Subject: Woodmoor Mountain Ranch Filing 1, Lot 35 - Variance Supplemental

Project File: VA2025-008

Attached is an additional correspondence received from the Woodmoor Mountain Homeowners Association (HOA), regarding the variance request.

Daisy - 40'x36'

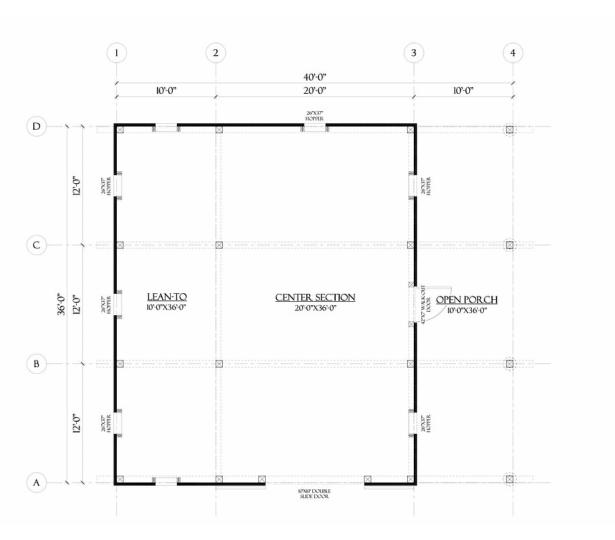
- Attachment D is the survey results of what actually was built, and where.
- 2) Attachments I and J are additional photos I have of the building as it stands as of about 4 days ago. You'll see it's substantially different from Attachment B.

- Attachment B has the height of the building at 20' at the roof peak; the constructed building appears from the literature and the truss plan to be 32'. 60% taller.

SCALE AS SHOWN In Sec. 20, Township 10 South, Range 67 West 6th P.M., Douglas County, Colorado. DATE 5-15-25

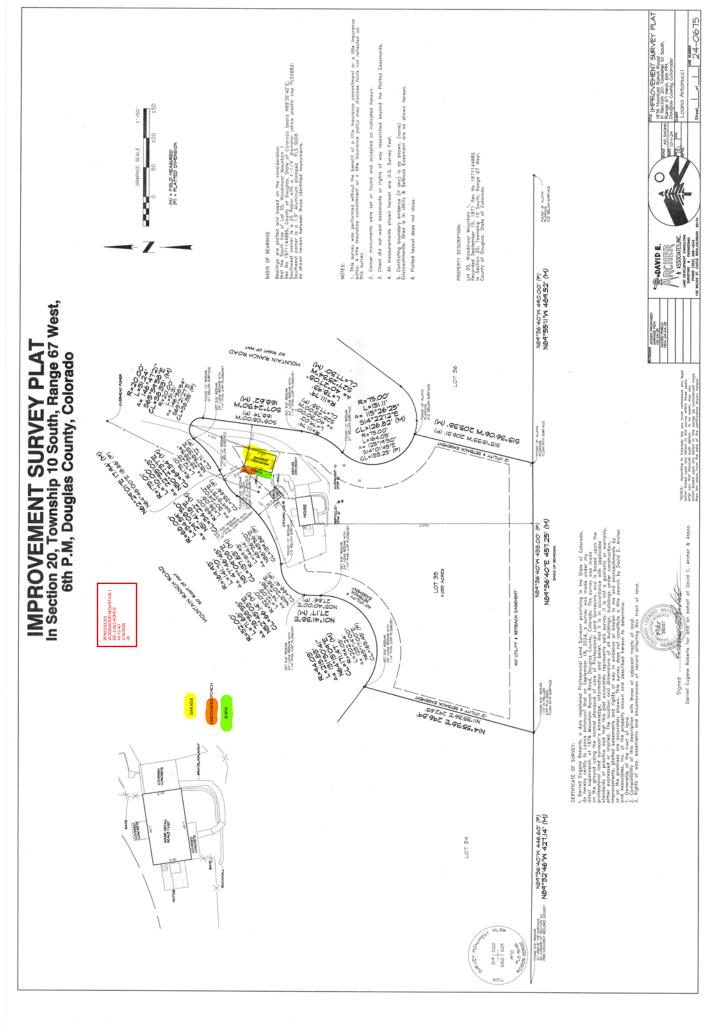
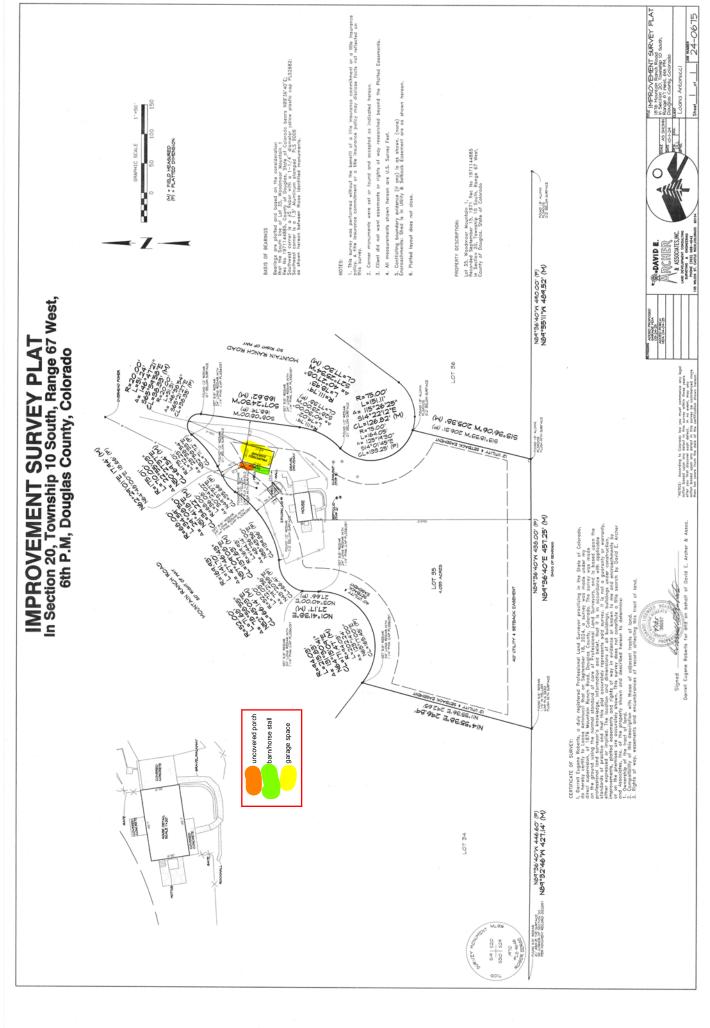
- Attachment D is the survey results of what actually was built, and where.
- Attachment E and F below, are the two site plans I found on the Building Department's public file showing what was submitted to them

- You'll see both sets show a main building of 48'x30', with the west side having an additional 10 ft extension to the west, the south half listed as a "barn" (green highlight). The measurements would be 10'x24', but no dimensions are included, so just measured from the scale of the drawing.

- The north section of the western addition is also 10'x24', but is shown as an uncovered porch, which in itself, wouldn't count against the setback.
 - But the north section is, in fact, covered. See Attachment G.

- From Attachment F: The picture below shows the supposedly uncovered porch (orange) extending an additional 6.2' into the setback (the long dashed line) beyond the NW corner of the supposed 48'x30' building. If attachment D, the "as built" survey shows the NW corner of the main structure at 23.2' from the property line, that makes the setback distance from the "real" NW corner, the covered porch, at 17 ft (23.2' minus the 6.2'). This should be the actual setback distance (for the garage) the which the variance request is made.

DESC Plan for 1876 Mountain Ranch Road – 30'x48' Garage

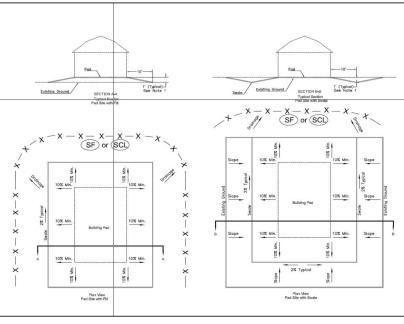
- You might find their claims of steep terrain a bit curious, as it isn't steep in the setback compliant area at all. Attachment H is the DESC plan from the Building Department file, and it doesn't even list any concerns about grade or erosion prevention.
